**TOWN OF NEWBURGH
PLANNING BOARD
TECHNICAL REVIEW COMMENTS**

PROJECT: MADISON ROSE PROPERTIES (119 FOXWOOD DRIVE)
PROJECT NO.: 18-21
PROJECT LOCATION: SECTION 16, BLOCK 3, LOT 11.1
REVIEW DATE: 31 DECEMBER 2018
MEETING DATE: 3 JANUARY 2019
PROJECT REPRESENTATIVE: TALCOTT ENGINEERING DESIGN/MIKE AIELLO

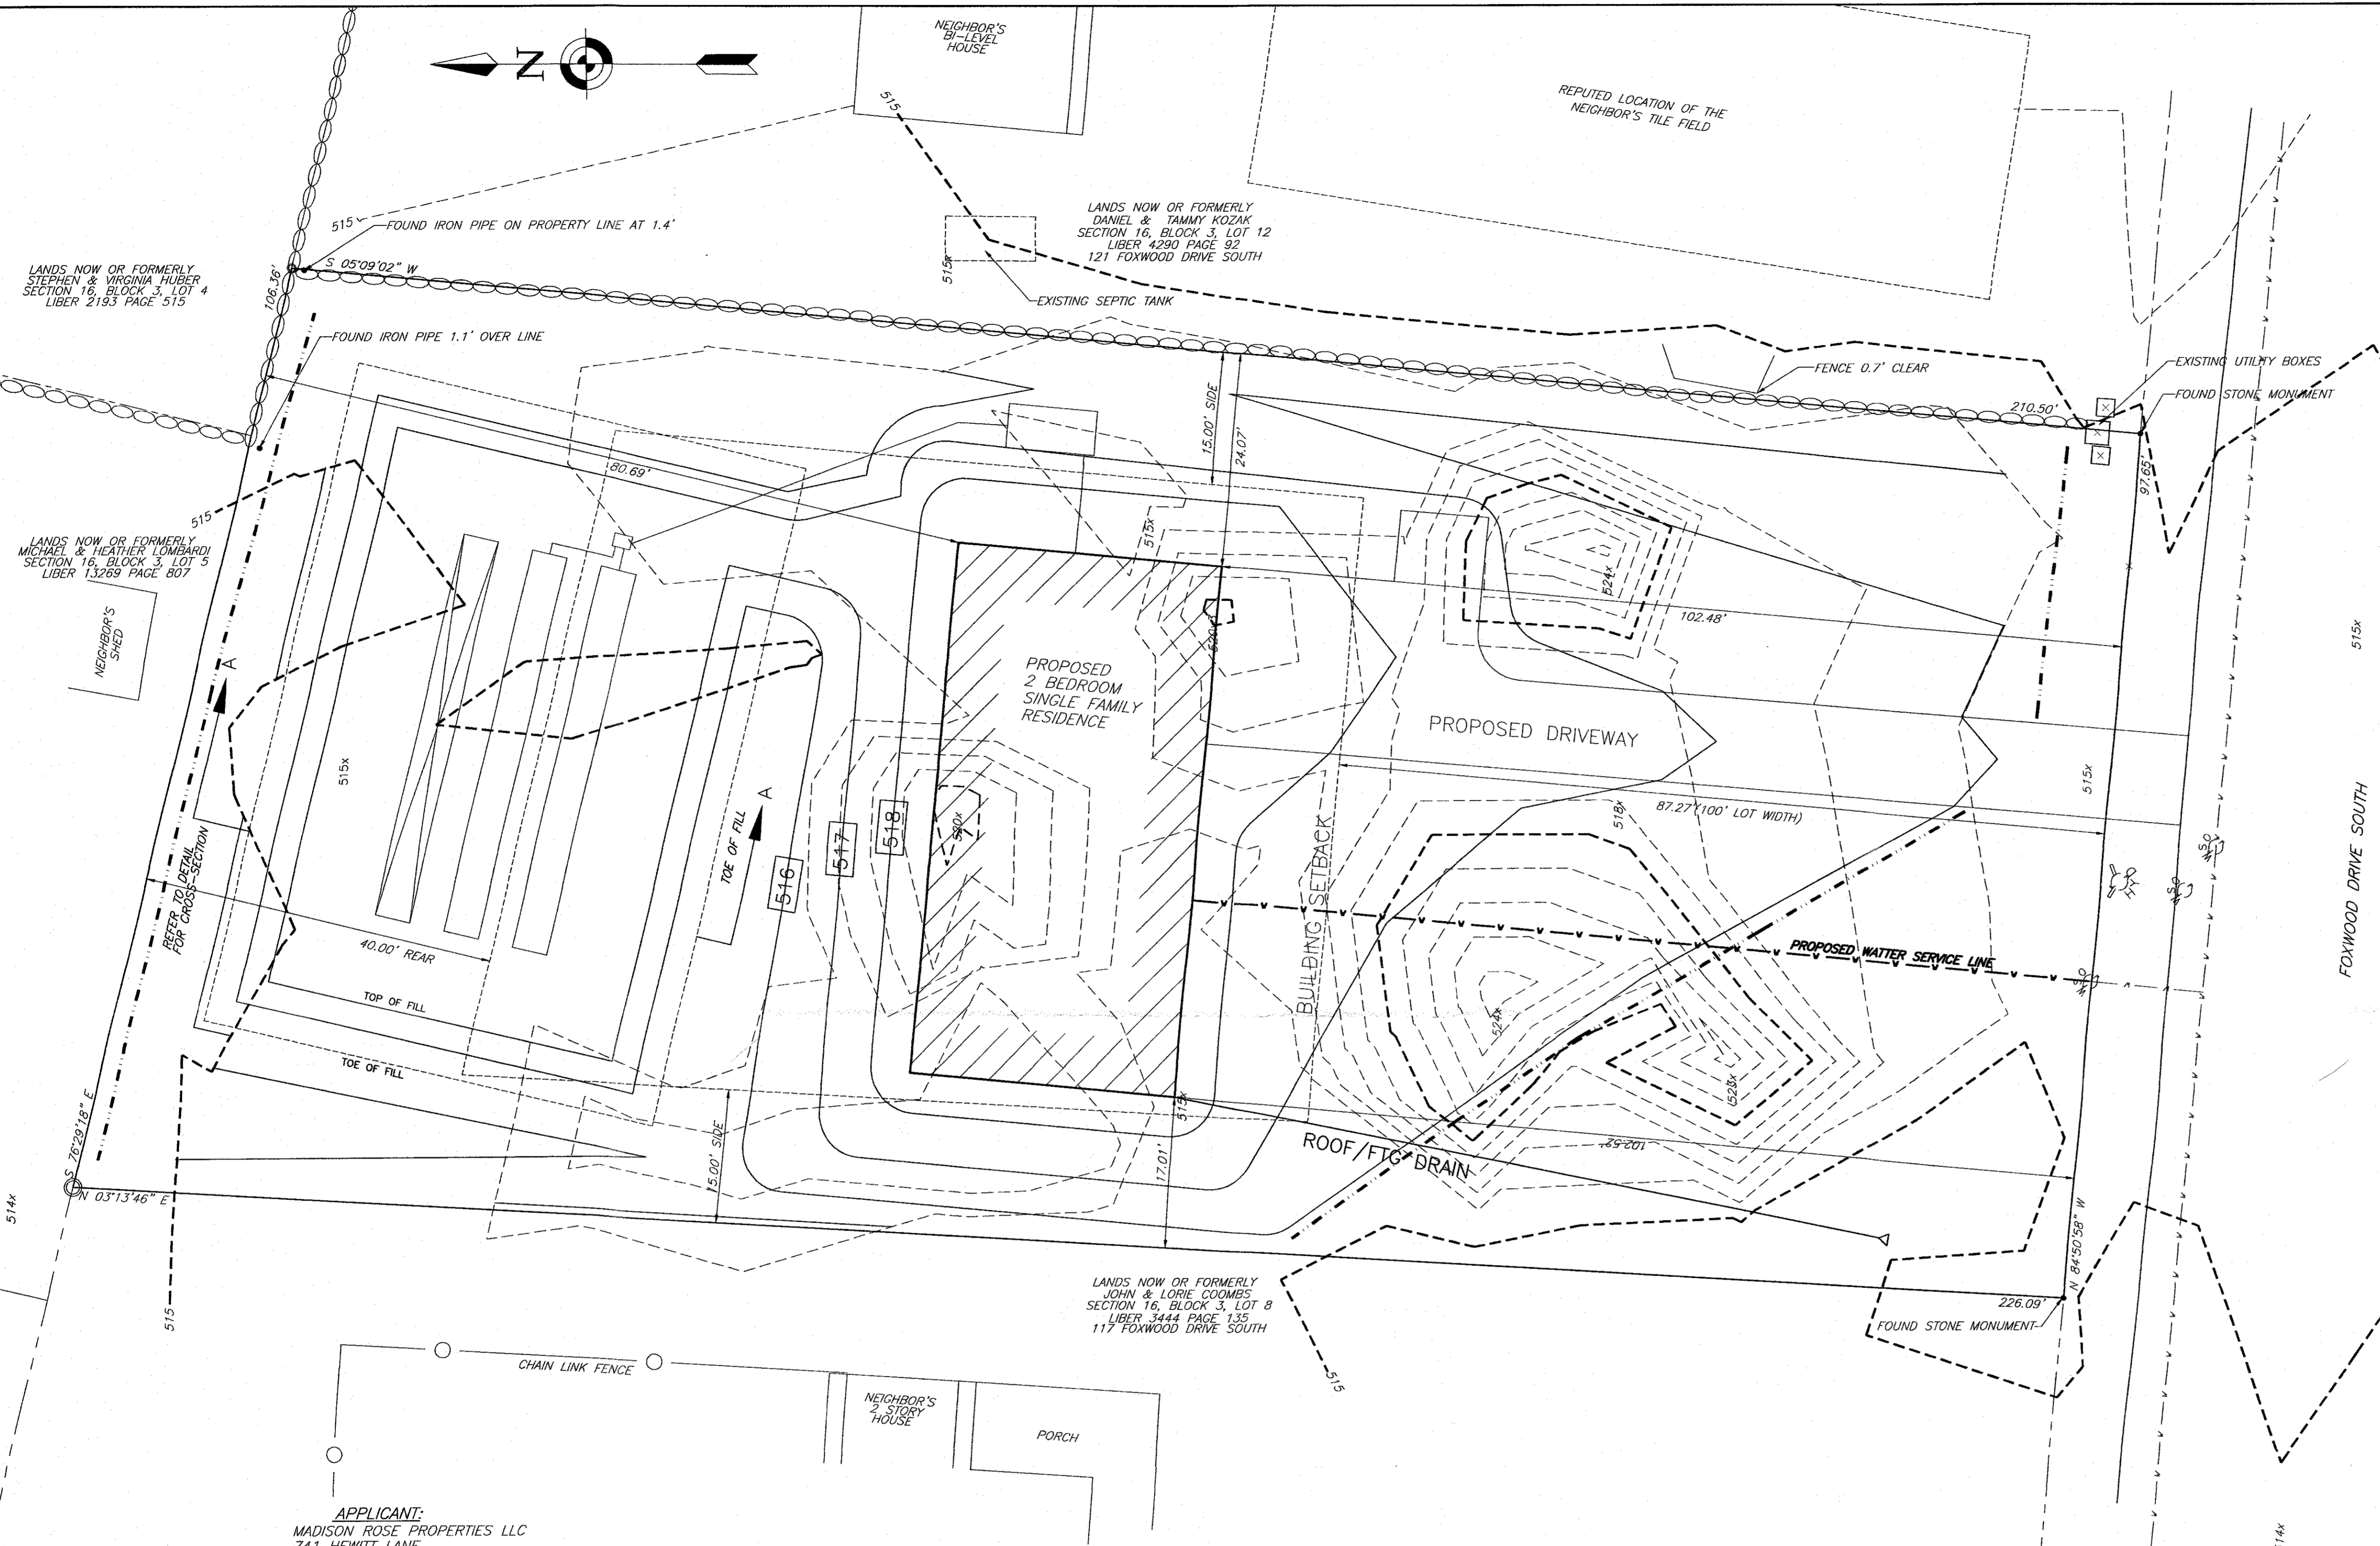
1. A separate plan sheet has been prepared identifying an actual field survey completed on 10 December 2018 showing the appropriate metes and bounds for the lot.

3. Erosion and sediment control details have been added to the plans.
4. Numerous piles of material exist on the site. These piles are proposed to be graded out based on the proposed grading plan.

5. The plan is presented as an amended subdivision plan to remove a "Not for Construction" notes from the original 1990's approved subdivision map.

ELJEN GRAVELLESS SAND FILTER (GSF) SHALLOW FILL PAD SECTION N.T.S. SECTION A-A

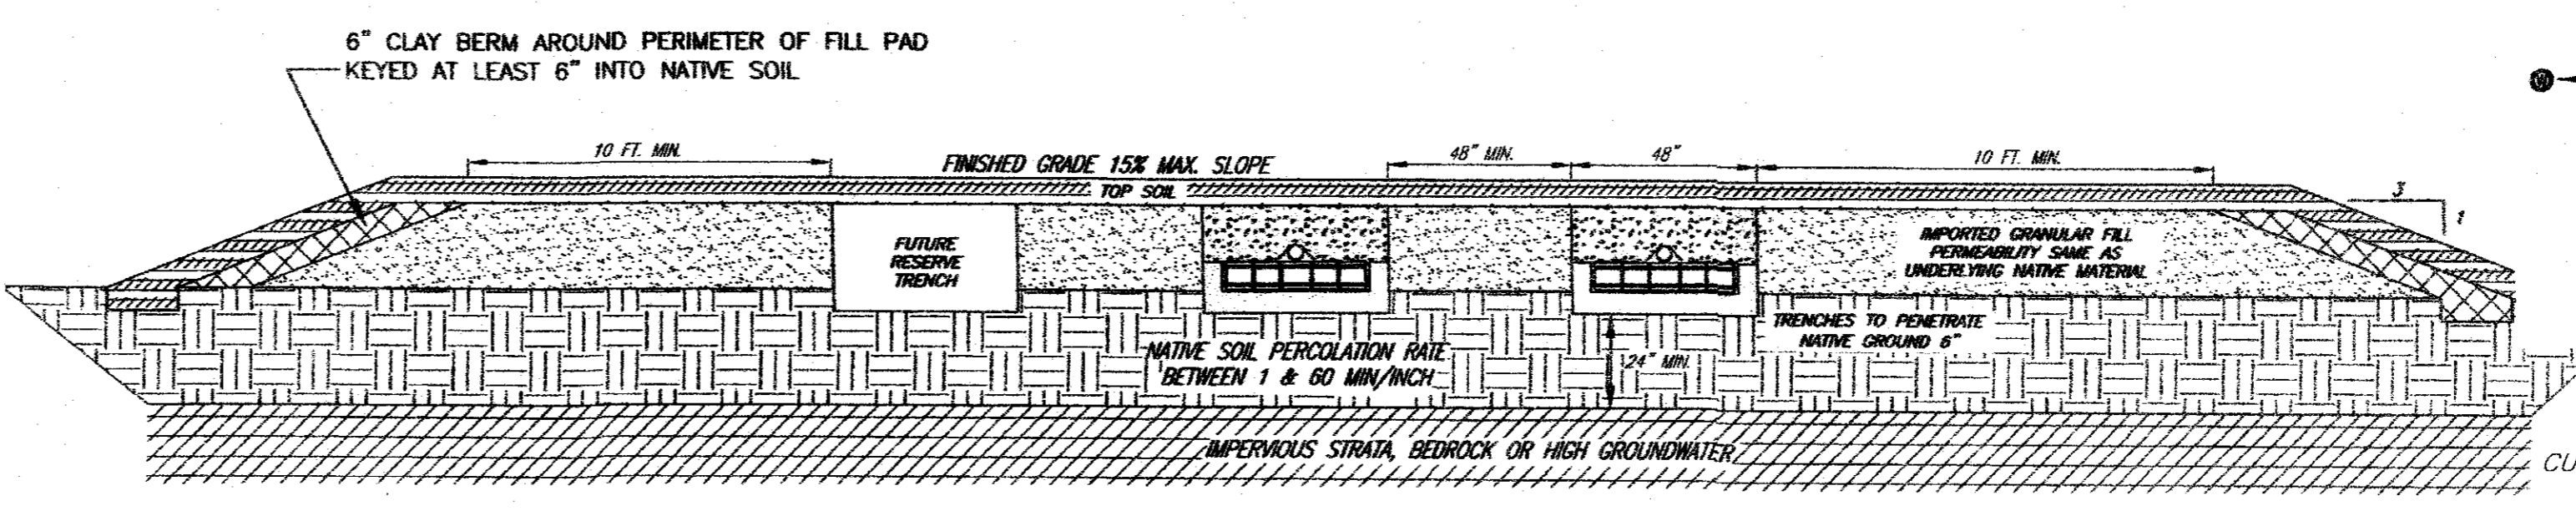
2. Notes regarding the requirement that a survey be performed prior to construction of septic and building foundations have been added to the plans. The Town of Newburgh's note requiring as-built survey is also added to the plan. The plan sheets reference the Health Department approval dated 31 July 2015 which remains valid for a period of 5 years from that date. Septic system has been approved by the County as a shallow absorption trench system utilizing Eljen in-drain proprietary septic laterals.
